PE14-030

**2010 thru 2012 Model Year Ford Fusion, Lincoln MKZ,
2010 thru 2011 Model Year Mercury Milan
Alleged EPAS failure while driving, resulting in increased steering effort**

2010-2012 Fusion / Milan / MKZ EPAS - Loss of assist while driving
Part Change Log

Photos for change 6

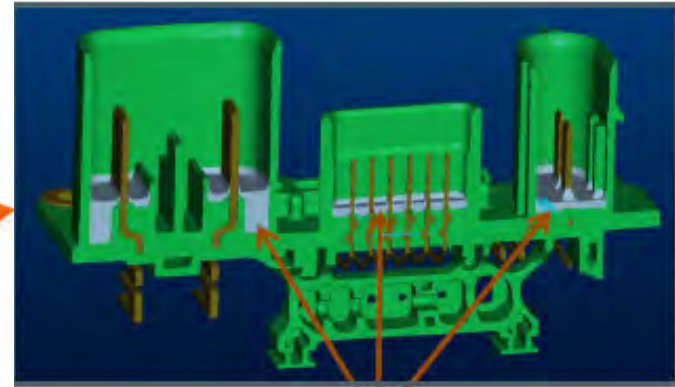
Potting material added around terminals

Photos for changes 1, 2, and 3

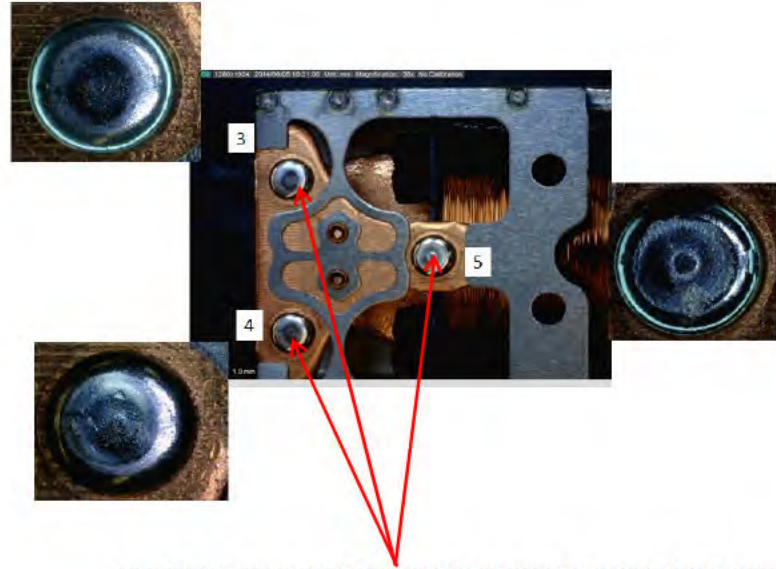
Ice can be generated on contacts prevent contacts from closing at start up.
